LEGAL NOTICE NO. 241

THE TRAFFIC SIGNS AND PEDESTRIAN CROSSING
(AMENDMENT) ORDER, 2001

Diagram 8
CLAUSE 16A

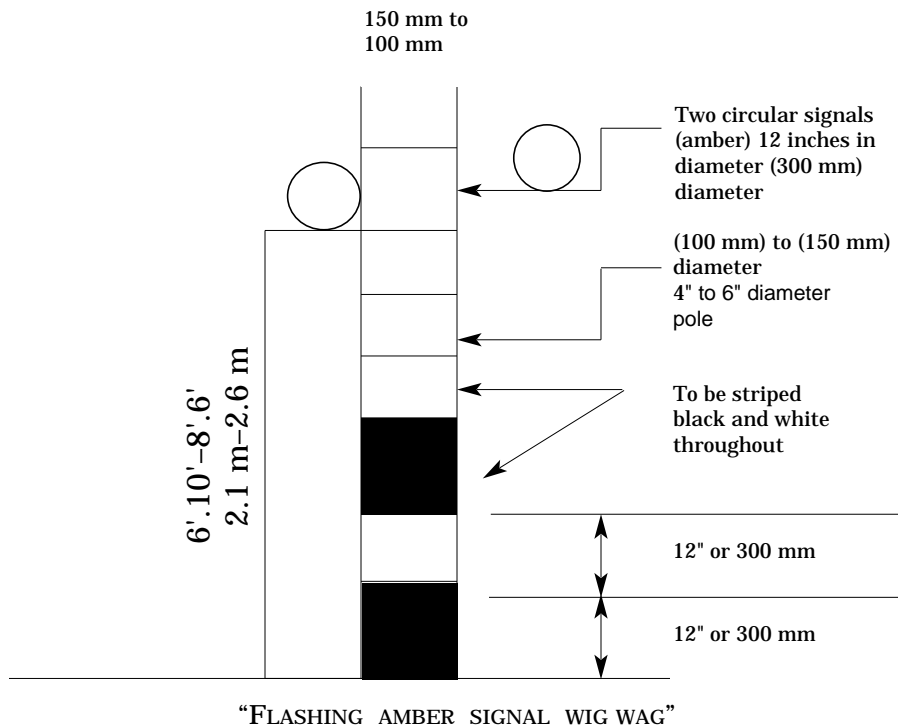
- (b) in Diagram 6 entitled “Zebra-Crossings-Road Markings (Single Carriageway) 2 Directional Traffic” by deleting the words “Globe (if necessary)” and substituting the words “Flashing Amber Signals, Globe or Danger Warning Sign.”; and
- (c) by inserting after Diagram 7 entitled “Zebra Crossing Street Furniture” the following new diagram:

“ZEBRA CROSSING STREET FURNITURE—WIG WAG”

- Clause 15 repealed 8. The Order is amended by repealing clause 15.
- Clause 16 inserted 9. The Order is amended by inserting after clause 16 the following new clause:
 “Traffic Sign (Wig Wags) 16A. (1) The traffic signs which may be placed at or near a crossing for the purpose set out in clause 16 may also consist of Wig Wags as indicated in Diagram 8 of the Schedule.

(2) Wig Wags shall be—
 (a) 300 mm in diameter; and
 (b) so mounted on posts at an average height of 2.5 m above the surface of the ground in the immediate vicinity of the crossing.

(3) The container which houses the apparatus for illumination of a Wig Wag shall be yellow or black in colour.
 (4) Wig Wags shall be illuminated by a flashing amber signal.

(5) Each post upon which a Wig Wag is mounted shall be coloured black and white in alternative horizontal bands, and shall be placed in such a position as to be clearly visible to approaching traffic.

(6) Each band shall be 300 mm in width and shall not be marked on any container which encloses the apparatus for providing the illumination of a Wig Wag.”
